MINUTES OF MEETING

K KANEPACKAGE PHILIPPINE INC.

AGENDA: 31. DISCUSS THE EXCESS GLUE ENCOUNTERED IN ITEM CODE 816298200 (LOUNGE & MICK ICB FOR ALIA, C)

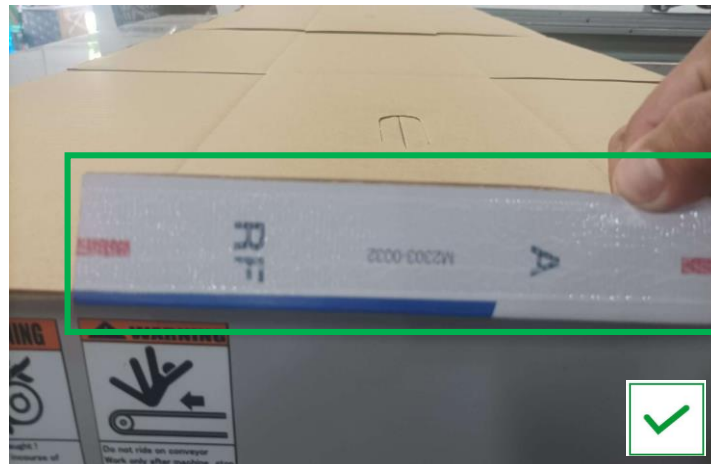
APPLICATION OF GLUE IN THE EDGE
OF THE GLUE TAB
(IMPROPER)

MINUTES:
 WHY 1: PEEL OF ENCOUNTERED IN ITEM CODE 816298200 (LOUNGE & MICK ICB FOR ALIA, C) DURING PROCESS
 WHY 2: PEEL OFF CAUSED BY EXCESS GLUE
 WHY 3: THERE WAS EXCESS GLUE BECAUSE THE 2ND GLUE WAS APPLIED FURTHER INSIDE THE PANEL AWAY FROM THE GLUE TAB
 WHY 4: THICK GLUE GOT ON THE EDGE OF THE GLUE TAB SO THERE WAS AN EXCESS INSIDE THE PANEL WHEN THE OPERATOR MOVED THE GLUE ROLLER, AFFECTING THE PLACE OF THE GLUE ROLLER APPLICATION BECAUSE THE ROLLER MOVED AWAY FROM THE GLUE TAB OF THE PANEL
 NOTE: THE OPERATOR SHOULD HAVE ADJUSTED THE GLUE PLATE BECAUSE HE NOTICED THE UNEVEN GLUE ON THE ROLLER
 WHY 5: OPERATOR ALSO FAILED TO UNDORED TRIAL AFTER THE ADJUSTMENT OF THE GLUE PLATE
 IMPLEMENTATION: THAT EVERY ADJUSTMENT THEY MUST UNDERGO TRIAL SAMPLES

APPLICATION OF GLUE WITH
ALLOWANCE BEFORE THE EDGE
(PROPER)
